BOARD ACTION REPORT – APPEALABLE ITEM

Project Name: 235 NE 1st Avenue
Project Location: 235 NE 1st Avenue, Old School Square Historic District
Request: Certificate of Appropriateness (2019-250) and Variance (2019-251)
Board: Historic Preservation Board
Meeting Date: October 2, 2019

HISTORIC PRESERVATION BOARD STAFF REPORT

Meeting	File No.	Application Type
October 2, 2019	2019-250 & 251	Certificate of Appropriateness and Variance

Drawing Title: NEW N-S-E-W ELEVATIONS of Main Residence

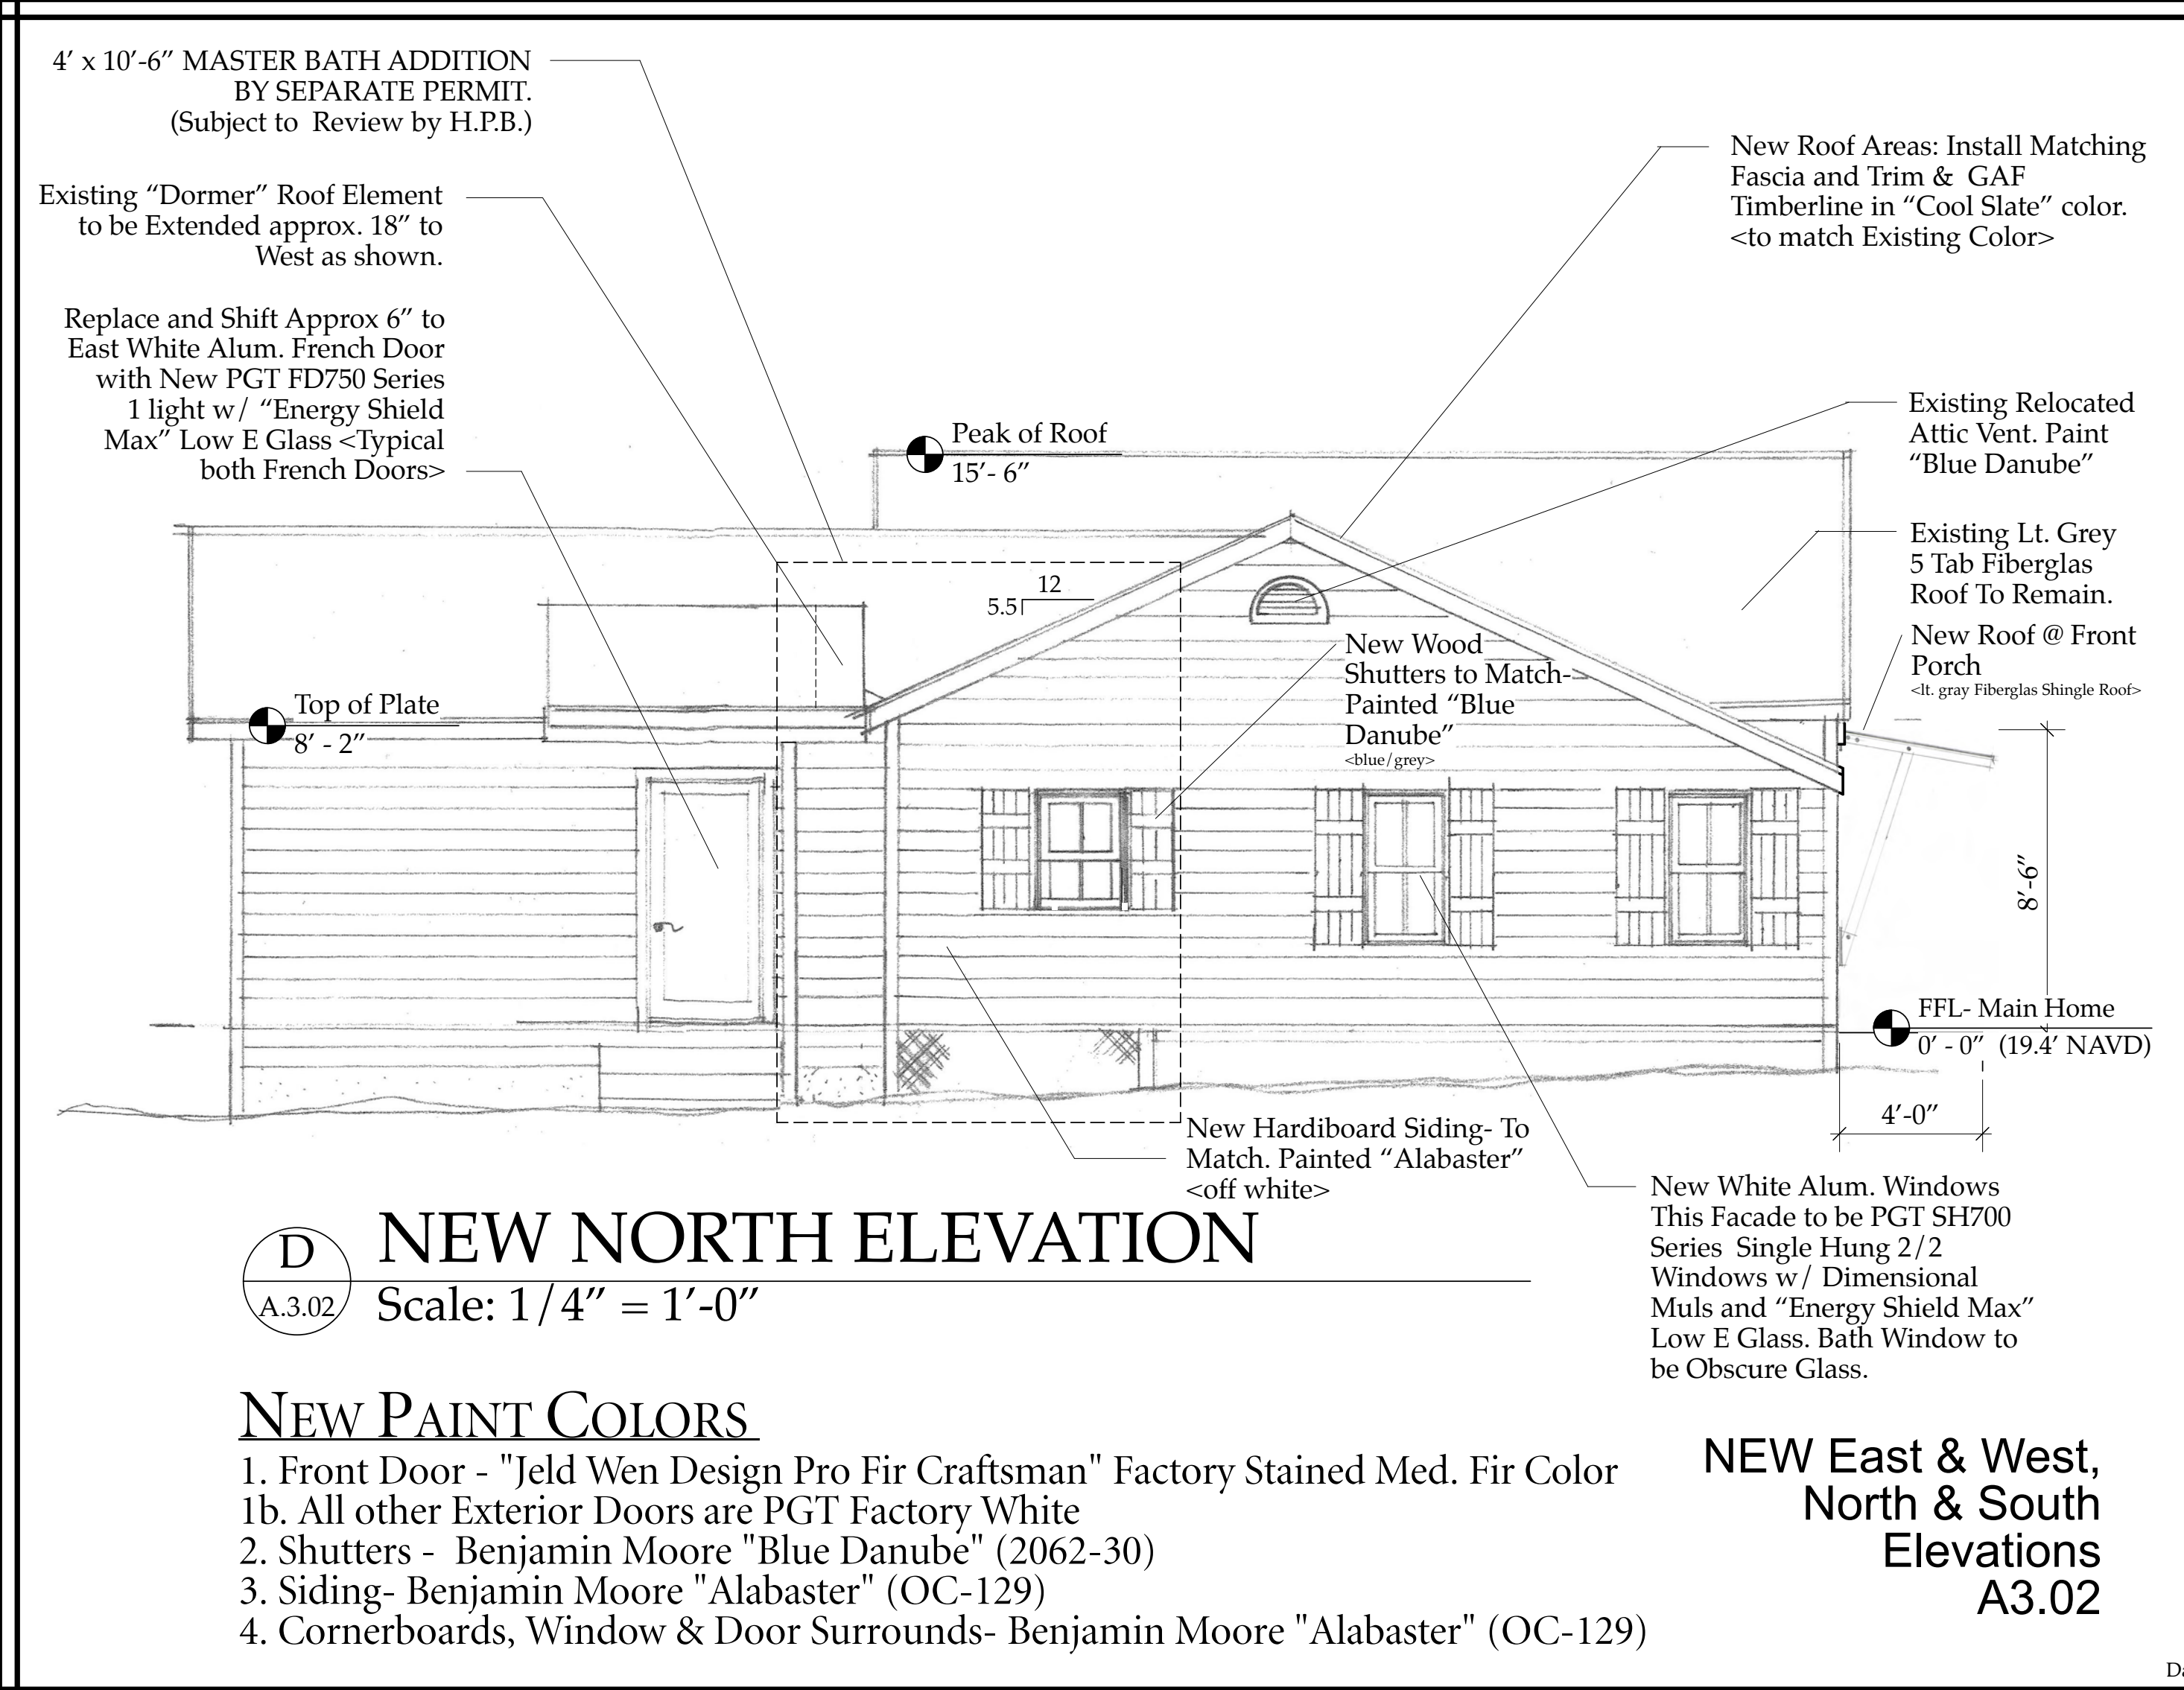
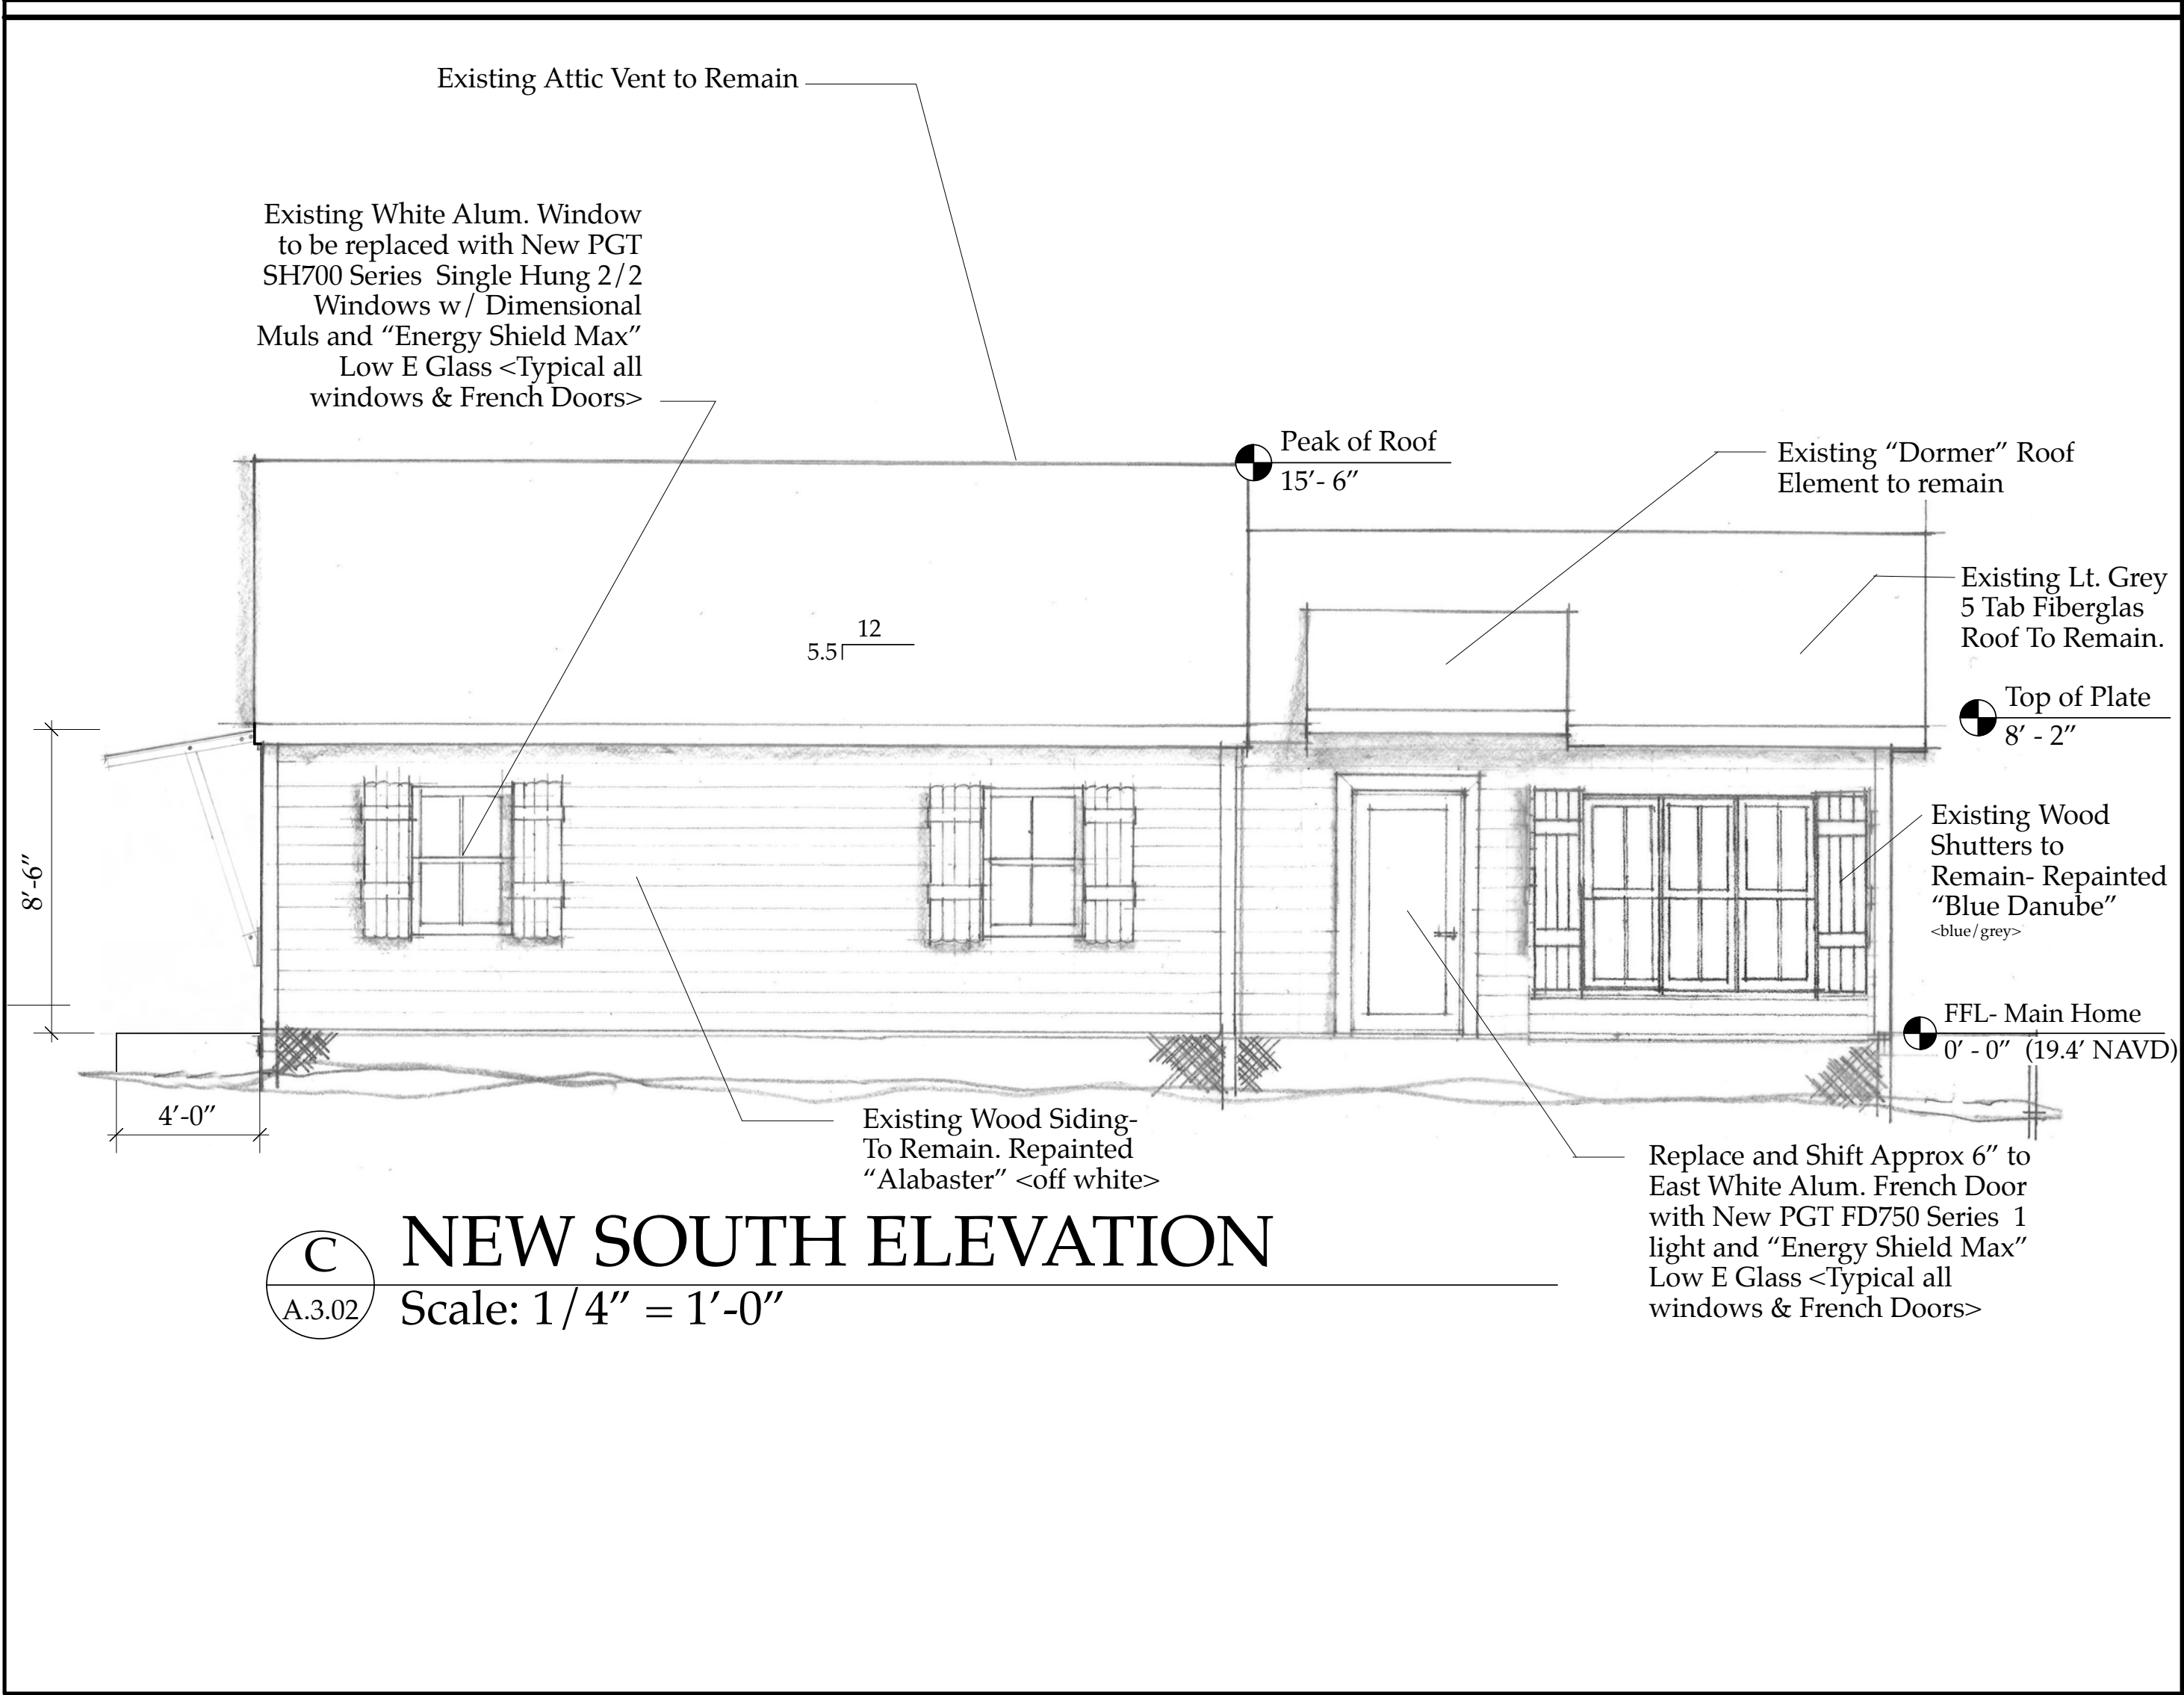
Standard 1, 2, 3, 5, 9, & 10 are applicable. The proposal includes replacement of the existing, projecting, fabric awning from the front façade with a wood framed, projecting and sloped, 3-dimensional asphalt shingle roof. It is noted that the elevation plans do not illustrate the existing fabric awning and must be updated to illustrate this existing condition. This item is added as a condition of approval.

The proposal includes replacement of the existing, projecting, fabric awning from the front façade with a more permanent projecting/sloped, shingle asphalt roof element. The new roof feature will have a wood frame. It is noted that the elevation plans do not illustrate the existing fabric awning and must be updated to illustrate this existing condition. This item is added as a condition of approval. The new porch roof shingles will be "Cool Slate", which is a light grey and will match the color of the existing shingle roof. As a contributing structure within an historic district, it is imperative that the architectural style and its original features be preserved accurately. The proposed slope roof does not introduce a new feature to structure as a projecting fabric awning exists in this location; therefore, it can be considered an appropriate alteration.

1. That the elevation plans be updated to illustrate the existing fabric awning on the façade; and,
2. That any proposed shutters to the front windows be created to appear operable, and that shutter dogs be used.
